**EPA Review of DOE Replacement Panels  
Planned Change Request**

**Part 1: Review of DOE 12-Panel Sensitivity Study**

U.S. Environmental Protection Agency  
Office of Radiation and Indoor Air  
Center for Waste Management and Regulations  
1200 Pennsylvania Ave, NW

Washington, DC 20460  
July 2025

**Figure 3. BRAGFLO grid used in the CRA19\_12P analysis with modeled area descriptions (dimensions in meters)**

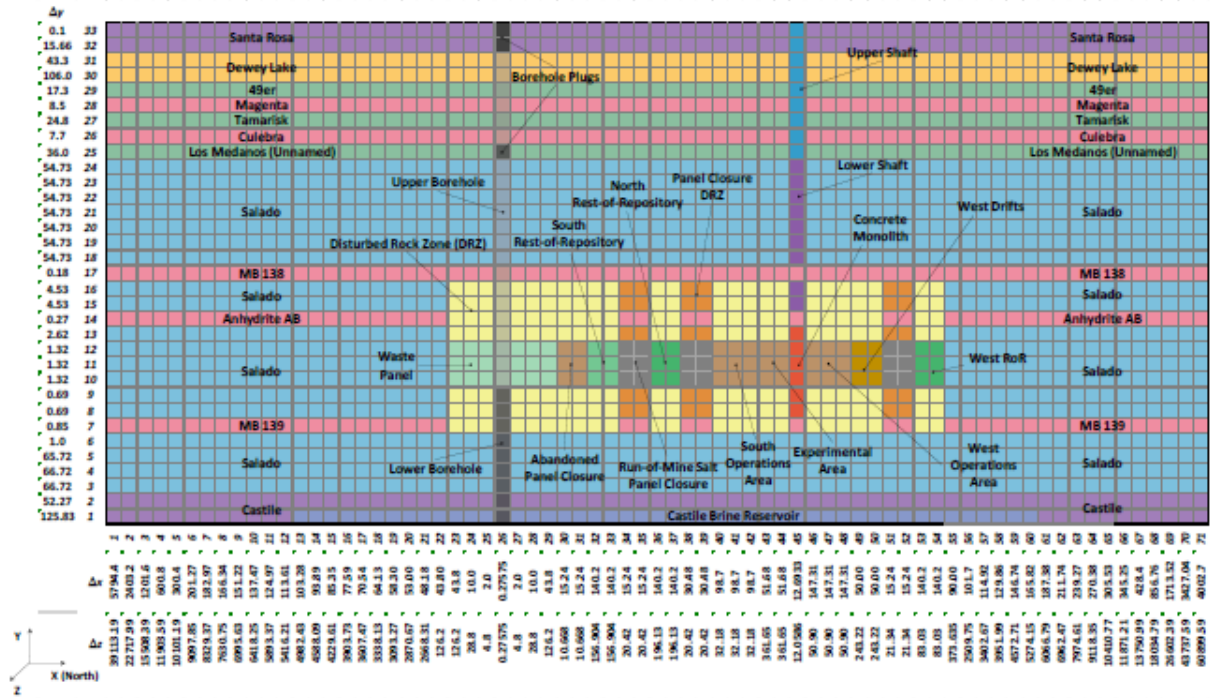
The CRA19\_12P BRAGFLO Salado flow grid is shown in Figure 3. The single intruding, surrogate borehole is shown intersecting a waste-bearing area on the left side of the grid, identified on the figure as the *Waste Panel*. Panel 5 always serves as the surrogate location for the first intruding borehole. This borehole location is conservative because the Waste Panel has the down-dip location and other physical characteristics of Panel 5 in Figure 2 that tend to result in higher brine saturations and greater repository releases. The remaining waste panels are up-dip from the Waste Panel and tend to be drier. The second and subsequent intruding boreholes can intersect the repository in any of the four waste-bearing areas, and the surrogate locations for these boreholes are shown in Figure 4.

With reference to the repository layout in Figure 2, the CRA19\_12P BRAGFLO Salado flow grid in Figure 3, and the CRA19\_12P DBR grid in Figure 4, the South Rest-of-Repository (South RoR) in the grid is a waste area with the physical characteristics of Panels 3, 4, 6, and 9, and represents an area with no closures between panels within it or between it and the Waste

The panel neighboring scheme used by DOE in the 12-Panel Analysis is summarized in Table 2. Inspection of the BRAGFLO Salado flow grid in Figure 3 suggests that the greater the physical separation of the two intruded panels in the model, the less effect the earlier intrusion will have on conditions in the panel that was intruded at a later time. EPA notes that, in the extreme case of non-adjacent panels, the pressure and brine saturation in the Waste Panel would likely have little effect on conditions in the West RoR because they are separated by a greater distance and at least two sets of intervening panel closures.

- Evaluated DOE's update of the Salado flow and DBR computational grids implemented in BRAGFLO. The conceptual modifications of the BRAGFLO Salado flow and DBR models proposed by DOE to accommodate off-axis, western waste panels were considered adequate for a 19-panel repository by the APPA Peer Panel (Falta et al. 2021, p. 28) and are also considered adequate for accommodating off-axis waste panels by EPA. EPA,

**Figure 4. BRAGFLO grid used in 12-panel analysis DBR calculations with modeled area descriptions (dimensions in meters)**

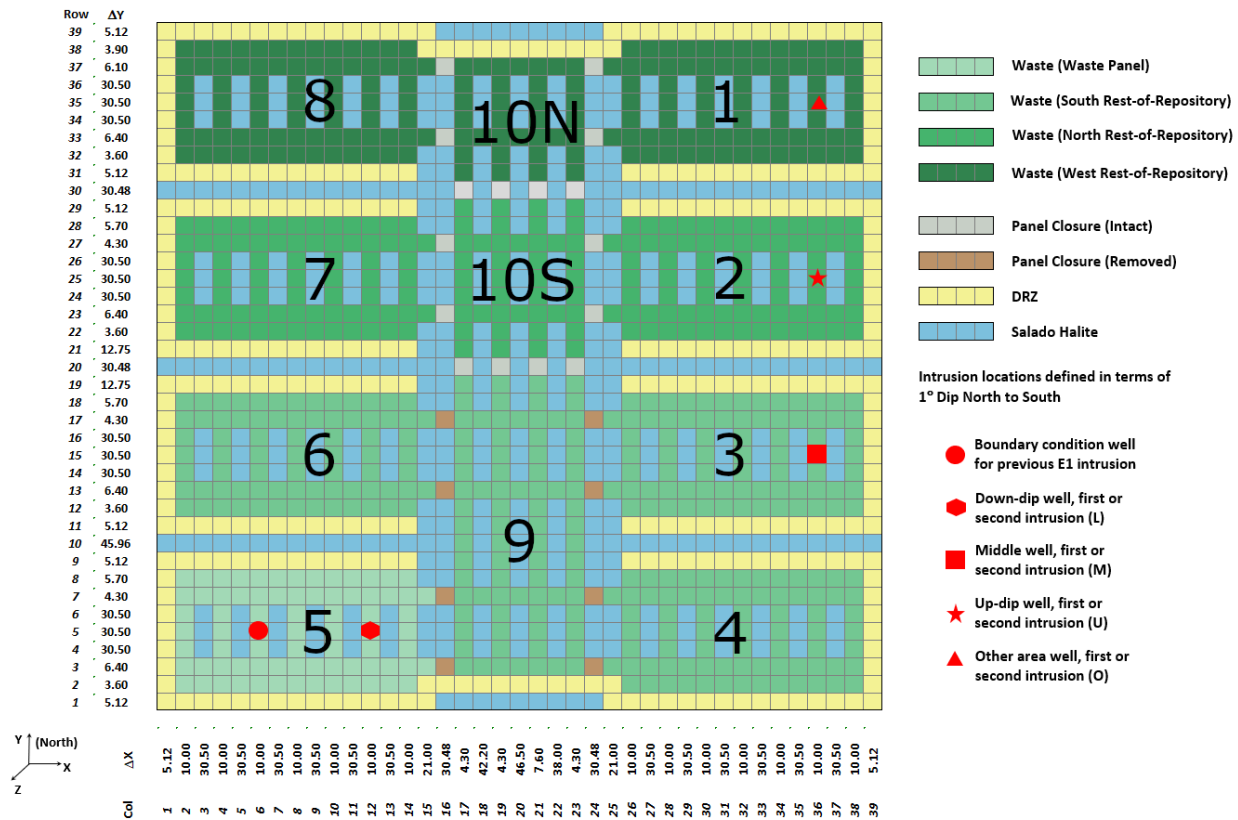
The BRAGFLO DBR grid is used in WIPP PA to simulate short-term brine and gas flow within the excavated repository drifts during a DBR. It provides a stylized, two-dimensional plan view of the locations and volumes of the waste panels within the repository. An illustration of the BRAGFLO DBR grid used in the CRA19-12P analysis is presented in Figure 4. The 12-panel DBR grid is physically similar to but conceptually different from the CRA-2019 DBR grid (DOE 2019, Appendix PA-2019, Figure PA-25). The CRA-2019 DBR grid represented a plan view of the ten original waste panels that was accurate in both layout and volume. The grid was conceptually modified for the CRA19-12P analysis by splitting the CRA-2019 grid representing Panels 1, 2, 7, 8 and 10 in the North RoR in half and inserting panel closures between the two halves. The upper half of the old North RoR grid (see Panels 1, 8 and the north (10N) half of Panel 10) now conceptually represents the West RoR, and the lower half (see Panels 2, 7, and the south (10S) half of Panel 10) of the old North RoR grid now conceptually represents the North RoR. The representations of the South RoR and Waste Panel (Panel 5) in the CRA-2019 DBR grid were unchanged in the CRA19\_12P analysis. This grid is similar to the 19-panel DBR grid prepared by DOE for the APPA Peer Review (Falta et al. 2021, Figure 4-2), but the upper half of the old North RoR grid now represents only the two replacement panels 11 and 12.

In this modified conceptualization of the DBR grid, the actual volumes of the 5-panel North and 2-panel West RoRs are each represented by the volumes of two and one-half waste panels. The actual volume of the North RoR is therefore under-represented, and the actual volume of the West RoR is over-represented. DOE justified these changes because DBRs occur over a relatively short time, and the North and West RoRs are isolated from the Waste Panel by one or more sets of low permeability panel closures. These considerations make conditions in the North and West RoRs relatively unaffected by pressure surges in the Waste Panel and therefore relatively insensitive to the actual panel volumes.

The conceptual modifications of the BRAGFLO Salado flow and DBR models proposed by DOE to accommodate off-axis, western waste panels were considered adequate for a 19-panel repository by the APPA Peer Panel (Falta et al. 2021, p. 28) and are also considered adequate for accommodating off-axis waste panels by the Agency. EPA, therefore, concludes that similar conceptual approaches are appropriate for developing Salado flow and DBR grids for a 12-panel analysis where two of those panels are located in an off-axis, West RoR.

**Figure 17. Normalized total releases for analyses CRA-2019 (CRA19), CRA19\_12P, CRA19\_COMB, and RPPCR\_12P. The upper 95 percent confidence limit for RPPCR\_12P analysis is also plotted. They are all under EPA regulatory release limits.**

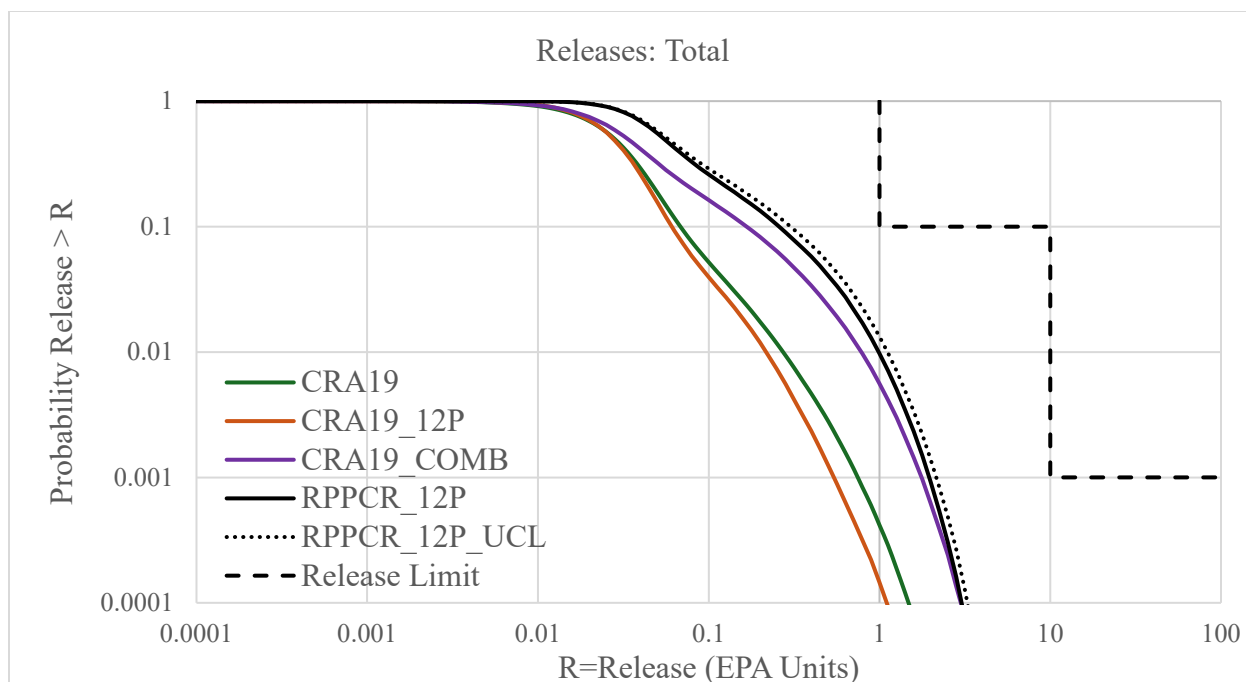
The overall mean CCDF is computed as the arithmetic mean of the mean CCDFs from each replicate. Figure 17 compares the overall mean CCDFs for total releases between the four analyses, CRA-2019, CRA19\_12P, CRA19\_COMB,<sup>1</sup> and RPPCR\_12P. Table 17 summarizes the comparison of releases for those analyses at EPA compliance points. As seen in Figure 17 and Table 17, total mean normalized releases for RPPCR\_12P and its upper 95 percent confidence limit (RPPCR\_12P UCL) remained below the regulatory limits of 1.0 EPA units at the upper compliance point and 10.0 EPA units at the lower compliance point.

The difference in total releases between CRA-2019 and CRA19\_12P analyses has been discussed in Zeitler et al. (2025) and summarized in Section 4 of this report. The release difference between CRA-2019 and CRA19\_COMB analyses has been discussed in EPA (2022c). The increase in calculated total mean repository releases in CRA19\_COMB, compared to CRA-2019, is due to the cumulative effect of parameter changes of borehole plugging pattern probability, actinide baseline solubility, colloid, and actinide oxidation state parameters. The parameter changes in the RPPCR\_12P analysis, compared to CRA19\_12P, are summarized in Section 6.1.

**Figure 18. Cuttings and cavings releases for analyses CRA-2019 (CRA19), CRA19\_12P, CRA19\_COMB, and RPPCR\_12P. The change in the drilling rate parameter in RPPCR\_12P has a direct impact on the releases of this release pathway.**

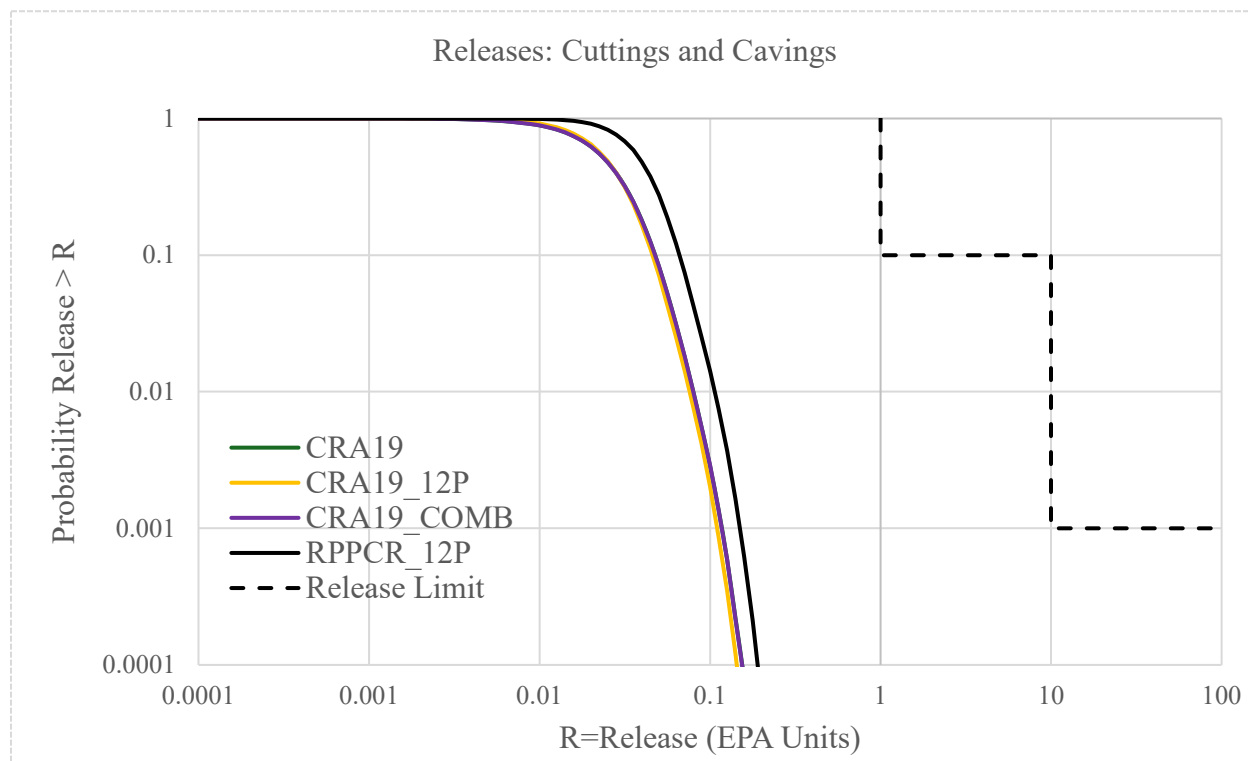
due to the parameter changes in the borehole drilling rate and iron surface density. The updated borehole drilling rate parameter has a direct impact on releases of the Cuttings and Cavings release pathway. As shown in Figure 18, RPPCR\_12P has significantly higher Cuttings and Cavings releases at both low probabilities and high probabilities.

**Figure 19. Spallings releases for analyses CRA-2019 (CRA19), CRA19\_12P, CRA19\_COMB, and RPPCR\_12P. The high drilling rate and high repository pressure conditions contribute to the higher spalling releases in RPPCR\_12P.**

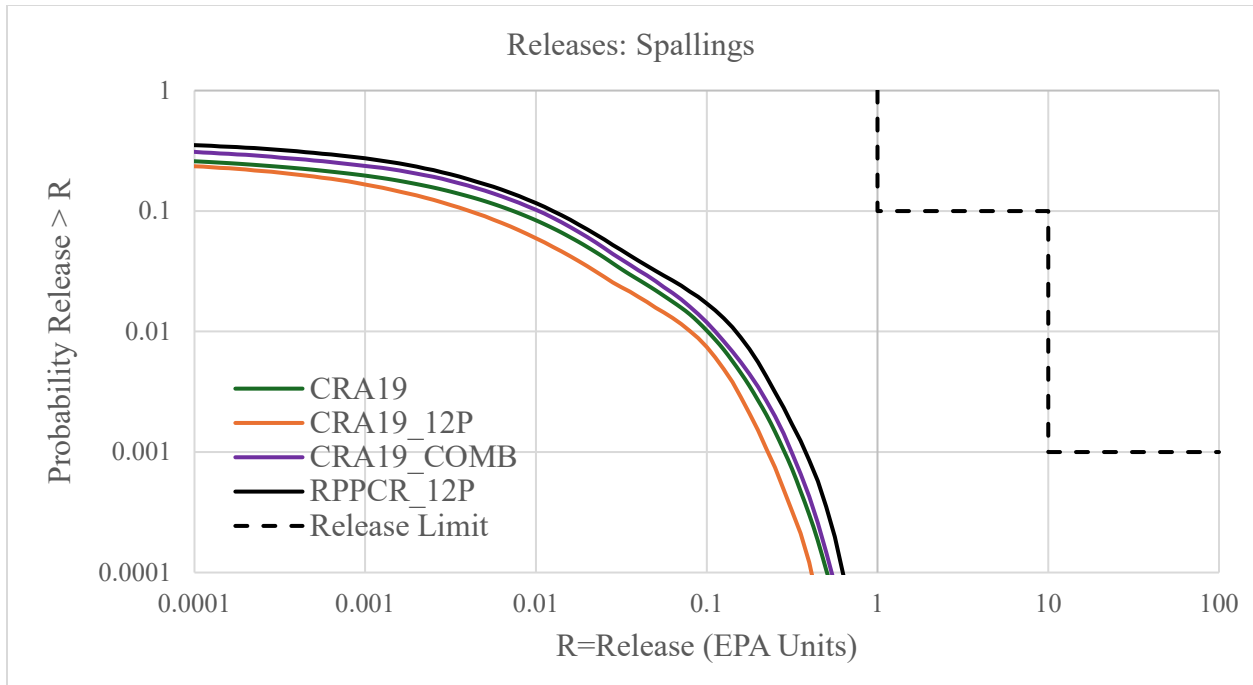
The larger repository volume in a 12-panel performance assessment decreases the iron surface density by 10 percent. It, in turn, decreases gas generation and brine consumption. The increase in releases for the Spallings pathway in the RPPCR\_12P, as shown in Figure 19, is a combined consequence of higher drilling rates and overall higher-pressure conditions in the repository. The higher-pressure conditions and the availability of brine in the repository increase the direct brine releases for the RPPCR\_12P, especially for the high probability, low consequence releases (Figure 20). The releases from the Culebra are not discussed here, as the contribution to the total releases from this release mechanism is minimal.
